Preliminary detailed assessment of other environmental regulations for General Nuclear System Limited's UK HPR1000 design - AR08

This report covers our Generic Design Assessment (GDA) of General Nuclear System Limited's (GNSL's) submission on information relating to other environmental regulations for the United Kingdom Hualong Pressurised Reactor (UK HPR1000) design as required in Table 1, Item 8 of our Process and Information Document (P&ID) (Environment Agency, 2016).

Figure 1: GNSL flow diagram for liquid radioactive effluent streams (GNSL, 2020b)

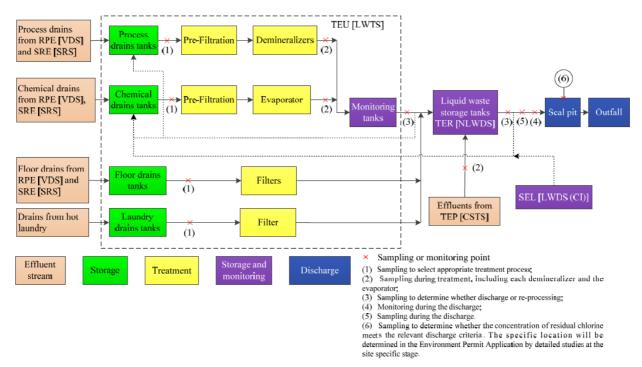
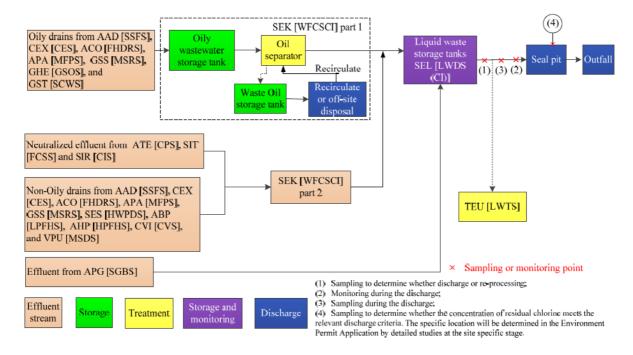
We noted that the flow diagrams provided (see Figure 1 above and Figure 2 below) included the option to either discharge the effluent directly into the environment (via the seal pit) or to divert it to be treated in the LWTS. We gueried (RQ-UKHR1000-0546) what controls would be in place when deciding to divert an effluent stream that would normally go directly to the seal pit for discharge to the treatment plant at the LWTS instead. GNSL confirmed that the effluent is expected to be non-radioactive for the majority of the time but may, on occasion, become contaminated by small leakages of radioactivity from the primary to the secondary circuit. The primary circuit contains the coolant that removes heat from the reactor. Heat from the primary circuit is transferred (via a heat exchanger in the steam generators) to water in a secondary circuit, which produces steam that is used to drive the turbines that power the generator to generate electricity. Any radioactivity would be picked up in the monitoring carried out when the effluent is held in the storage tanks that are part of the LWDS(CI). Subsequently, the decision to discharge directly to the seal pit and into the environment (if no radioactive contamination or acceptable levels of chemical contamination is present) or to the LWTS for treatment is made by the operator, based on limits defined in its operating instructions. We are satisfied with the operational flexibility this diversion route offers in term of increased protection of the environment and will follow this through to our site-specific permitting stage to ensure the management systems and procedures provide for robust decision making at this crucial point in the system.

In the PCER, there are 7 flow diagrams used to describe the effluent management system. In an earlier version of the PCER, we noted some inconsistencies between the diagrams themselves and between the diagrams and the associated text, and we queried these in RQ-UKHPR1000-0546 and RQ-UKHPR1000-0823. GNSL accepted the comments and has made the necessary amendments in its latest version of the PCER (GNSL, 2020b).
